May 7, 2025  
Project No. 210262

**Change Order 14 – City of Grand Ledge Iron Removal Plant, Description, and Impact**

CONTRACT FOR: City of Grand Ledge Iron Removal Plant  
OWNER: City of Grand Ledge  
310 Greenwood Street  
Grand Ledge, MI 48837  
CONTRACTOR: RK Davis, Inc.  
4457 40th Street, SE  
Kentwood, MI 49512  
ENGINEER: Fishbeck  
1515 Arboretum Drive, SE  
Grand Rapids, MI 49546  
ATTACHMENTS: Bulletins 11 and 13 Pricing Responses, Change Proposals for Chemical Transfer Pump and Carrier Water Pump Modifications

### Standard N - Module

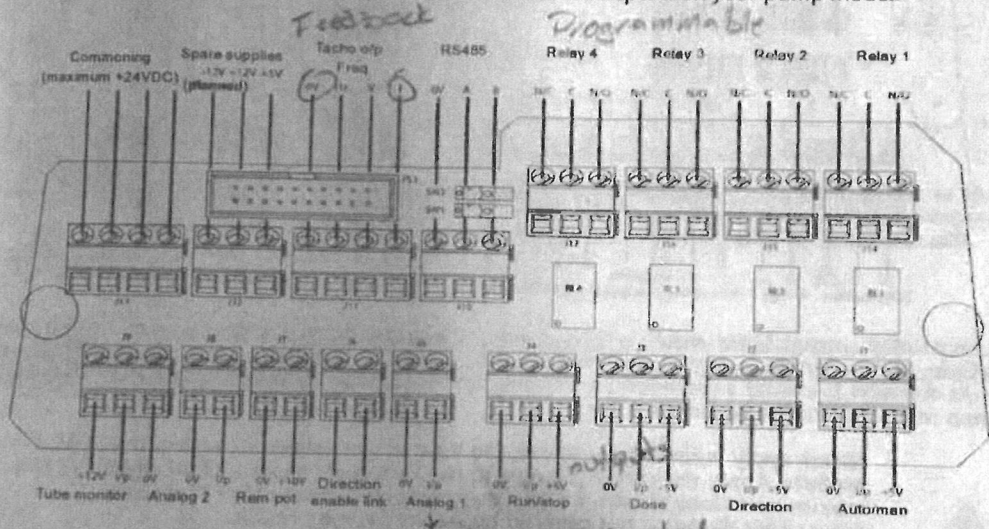
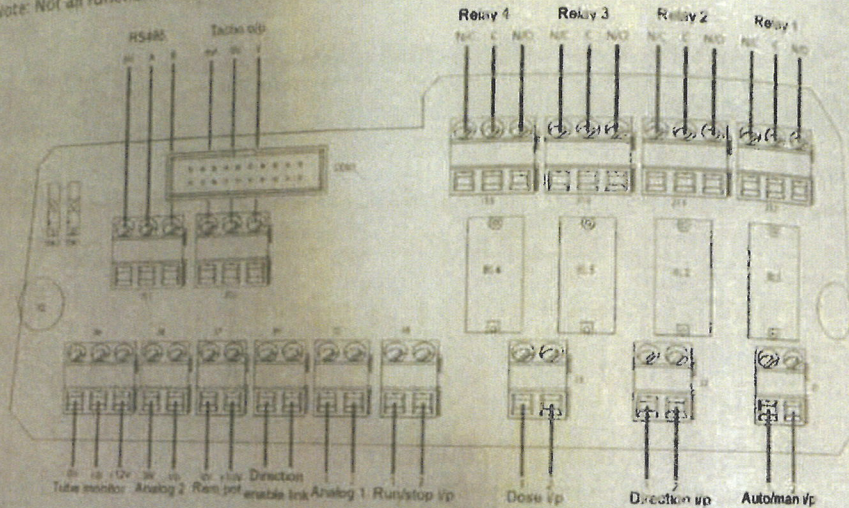
Please see Tim's email below. I don't know what was submitted on, but the pumps supplied with the Standard N control module are not compatible with the SCADA system. It will need to be the SCADA N control module.

STP-1 and MTP-1 are Watson Marlow pumps with an integral controller. They were supplied with the wrong boards(modules). The two pictures below are from the owners manual and show what was provided and what is needed. The pumps were supplied with the Standard N module, but we need the

SCADA N module to be compatible with the SCADA system. Shawn has talked to Watson Marlow and the correct modules can be ordered and installed in the pumps on site. I'm not sure how long it will take FHC to get the correct boards, so please pass this information onto all parties. Thanks

### SCADA N-Module
